**SAFETY EVALUATION BY
THE OFFICE OF NUCLEAR REACTOR REGULATION**

LICENSING TOPICAL REPORT NEDC-33006P

**"GENERAL ELECTRIC BOILING WATER REACTOR
MAXIMUM EXTENDED LOAD LINE LIMIT ANALYSIS PLUS"**

**GENERAL ELECTRIC HITACHI NUCLEAR ENERGY AMERICA,
LLC**

Figure 1-1 MELLLA+ Operating Range Power/Flow Map

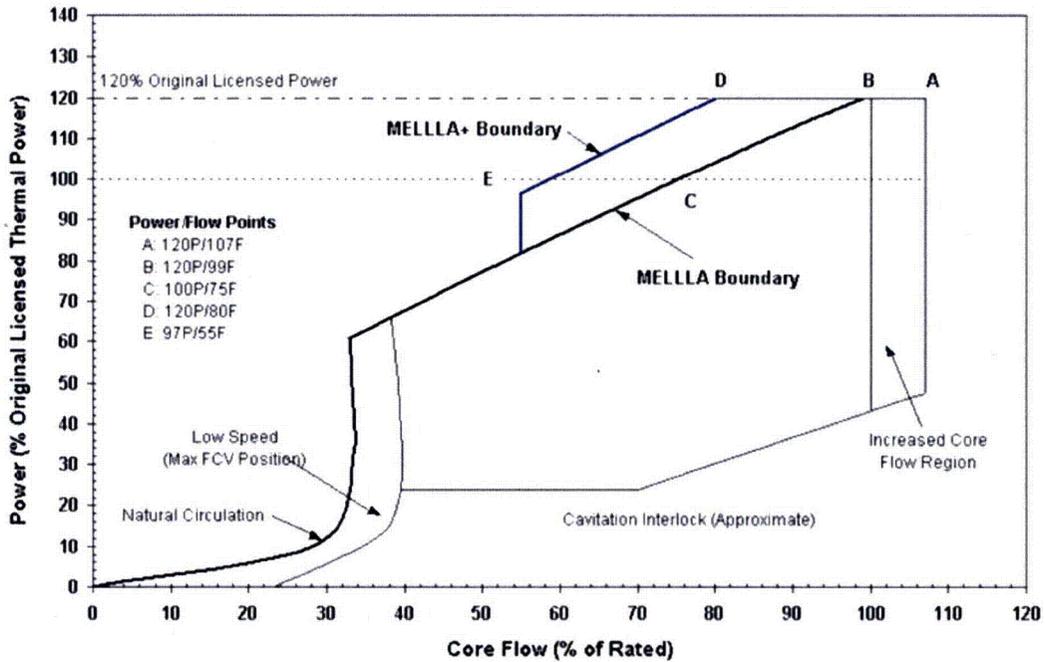
As seen in Figure 1-1, the flow control window in EPU reactors is very small (approximately 1 percent flow). Therefore, reactor operators are forced to either move control rods very often or allow power changes as burn-up takes place. In a typical EPU reactor, the control rods must be repositioned almost on a weekly basis to maintain power at the licensed level.

MELLLA+ attempts to address this flow control issue by increasing the operating range to point D of Figure 1-1 (120 percent OLTP, 80 percent flow); thus creating a 20 percent flow-control window. The EPU plants operating in the MELLLA+ range will require significantly lower number of control rod movements than presently licensed EPU plants. This represents a significant improvement on operating flexibility. It also provides safer operation, because reducing the number of control rod manipulations: (a) minimizes the likelihood of fuel failures and (b) reduces the likelihood of accidents initiated by reactor maneuvers required to achieve an operating condition where control rods can be extracted. However, this safety increase must be compared to other factors such as the higher power effect on transients and the fact that more channels are placed closer to limits by the power-profile flattening.

Figure 1-1 shows the MELLLA+ operating domain. The MELLLA+ operating domain is bounded by an analytical line that extends from 55 percent CF to the minimum CF statepoint (e.g., 80 percent CF) at EPU power level and the CF window at EPU power level (80 percent to rated or ICF at EPU power level).

Figure 2-1 Illustration of the power-flow map, showing that MELLTA+ operation will result in deeper penetration inside the instability region following a two-pump RPT

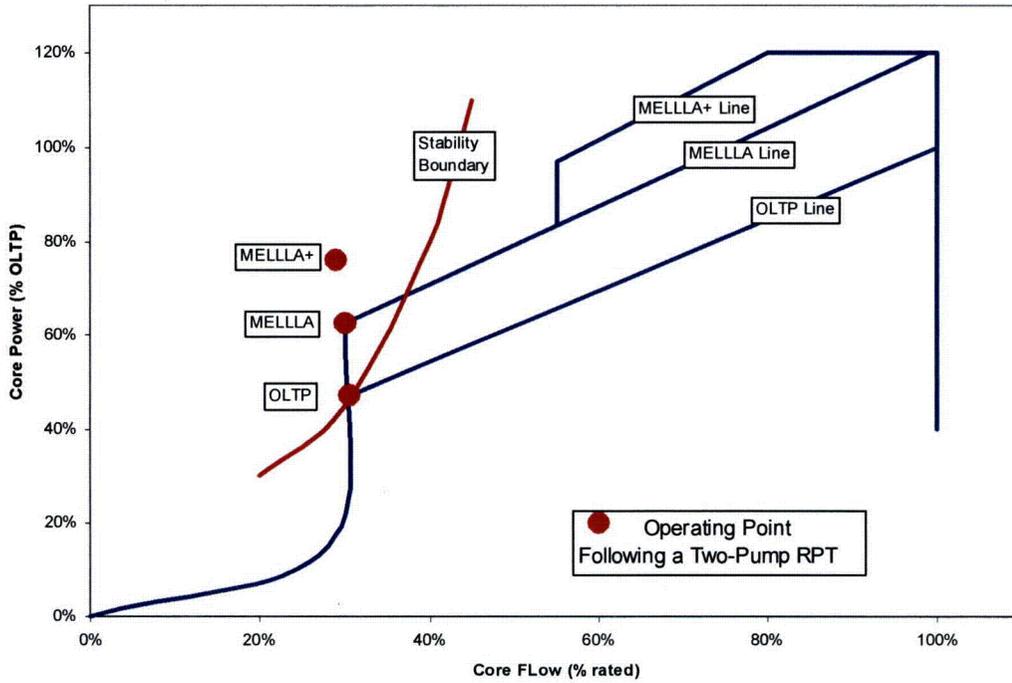
Figure 2-1 of this SE illustrates the reasons for the decrease in stability margin induced by MELLLA+ operation. This figure represents a typical reactor power-to-flow map, with a typical stability boundary line. Operation in the instability region (to the left of or above the stability boundary) can result in unstable power oscillations. As seen in this figure, when operating in the OLTP 100 percent rod line (e.g., at 100 percent OLTP, 100 percent flow), the reactor may or may not become unstable following a 2RPT. When operating on the MELLLA rod line (e.g., 120 percent OLTP, 99 percent CF), the reactor enters the instability region following a 2RPT; thus, the possibility of instability is high. When operating on the MELLLA+ line (e.g., 120 percent OLTP, 80 percent CF), the final operating point following a 2RPT is so far into the instability region that unstable power oscillations are essentially guaranteed.

Figure 2-4 Illustration of DSS/CD Defense in Depth Algorithms

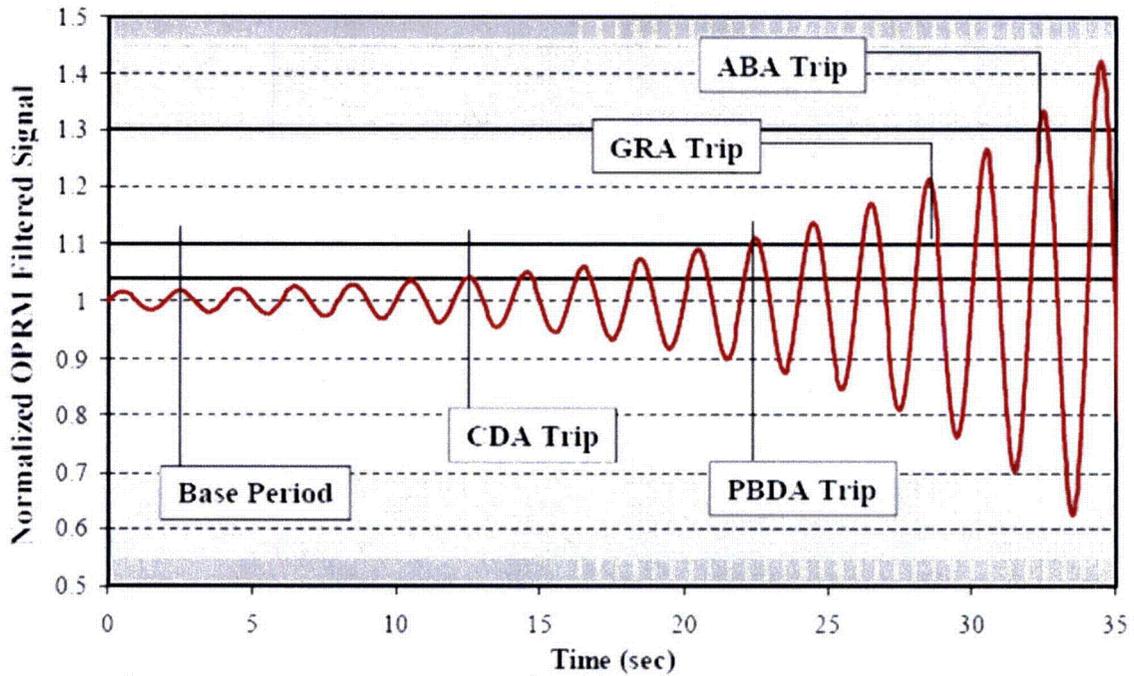
Figure 2-4 of this SE illustrates the operation of the main DSS-CD algorithm (CDA) and the defense-in-depth algorithms (PBDA, GRA, and ABA). The defense-in-depth algorithm would only be required in case the CDA algorithm failed for an unforeseen reason. They are armed when the oscillation amplitude reaches either 10 percent (PBDA and GRA) or 30 percent (ABA).

Figure 9-1 Illustration of reactor power during ATWS events from MELLLA+ and OLTP initial conditions. The final power is significantly larger under MELLLA+

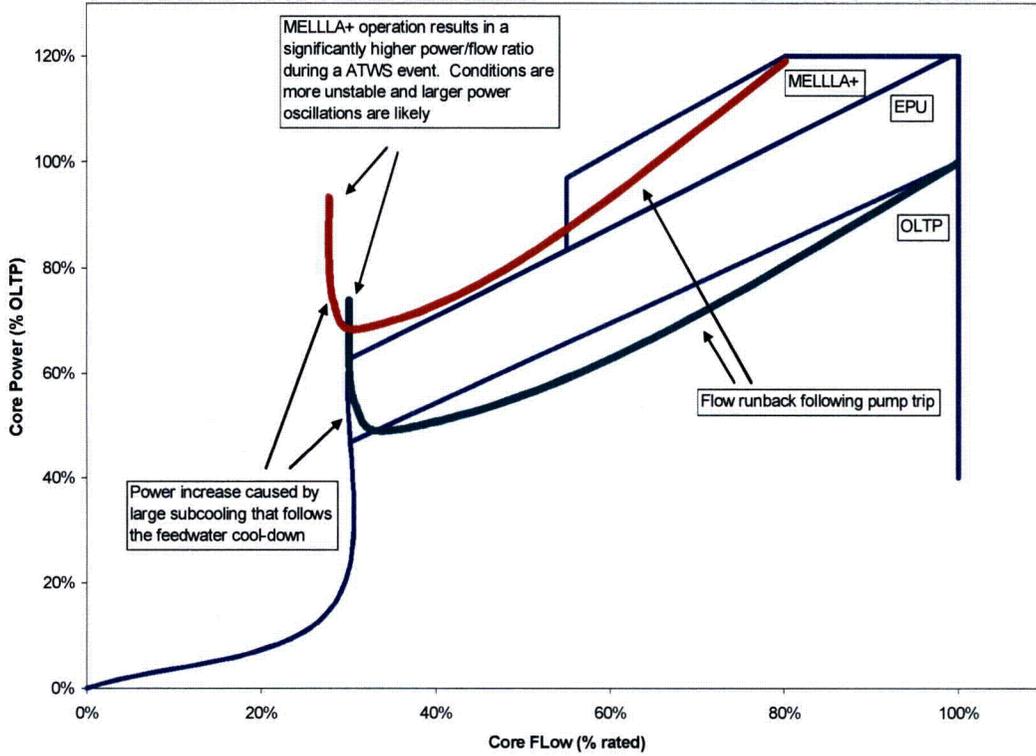
The NRC staff review indicates that, in principle, MELLLA+ operation affects ATWS-Stability. Operation in the MELLLA+ corner (120 percent OLTP, 80 percent CF) results in the reactor settling at significantly higher power, following a RPT, than the event initiated at rated OLTP condition. This higher power makes the final power even larger after the feedwater cool-down period. Thus, at least in principle, the unstable power oscillations are enhanced under MELLLA+, and their consequences should be more severe. This effect is illustrated in Figure 9-1.

Figure 9-8 Reactor power calculated by TRACE for isolation ATWS.

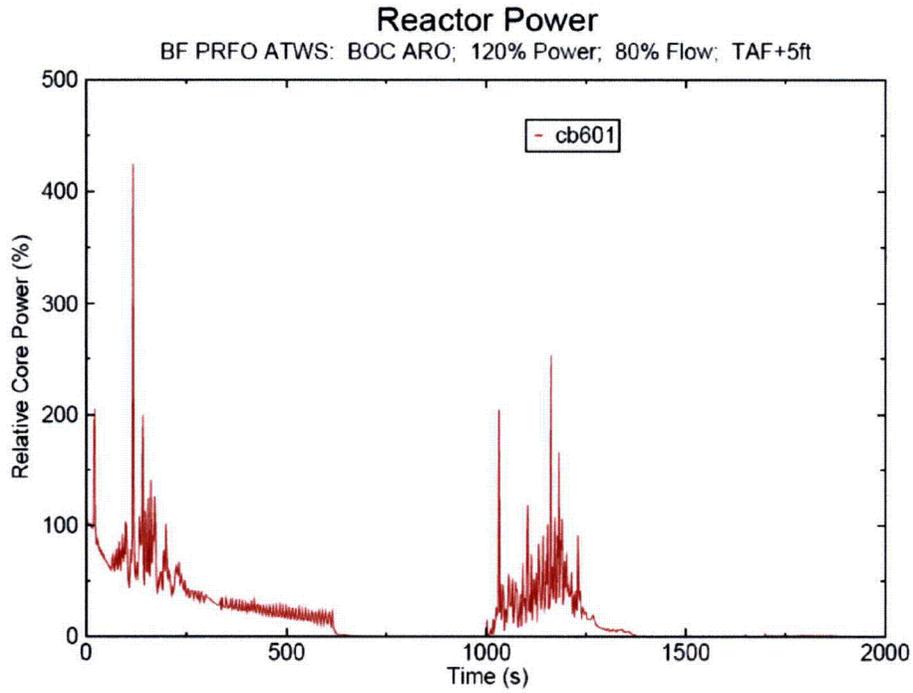
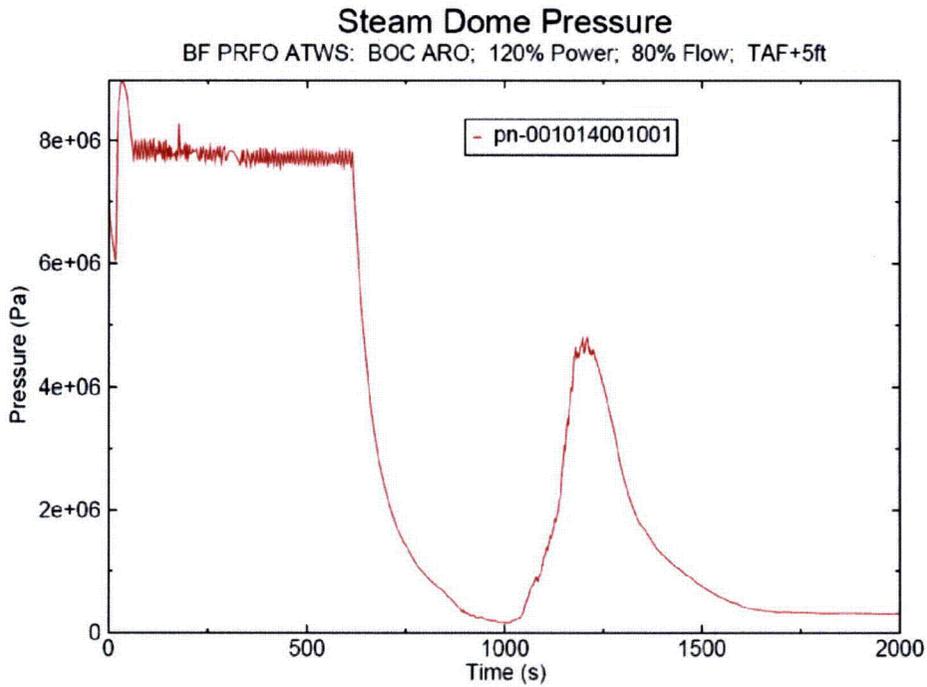
reactor shutdown. During this period, the power level oscillates wildly, and it reaches spikes as high as 200 percent OLTP, with an average of 50 percent to 70 percent. See Figure 9-8 and Figure 9-9 of this SE. The HCTL and emergency de-pressurization start at approximately 600 seconds. Following the emergency de-pressurization, the reactor becomes critical and the pressure recovers. Following a short closure to maintain pressure above 50 psi at time approximately 1000 seconds, all SRVs are open during the re-pressurization event at time approximately 1100 seconds. The calculated suppression pool temperature indicates that containment limits would have been violated in this transient (see Figure 9-10). The HCTL is reached in ~600 seconds. The final pool temperature for the TRACE calculation is approximately 240EF.
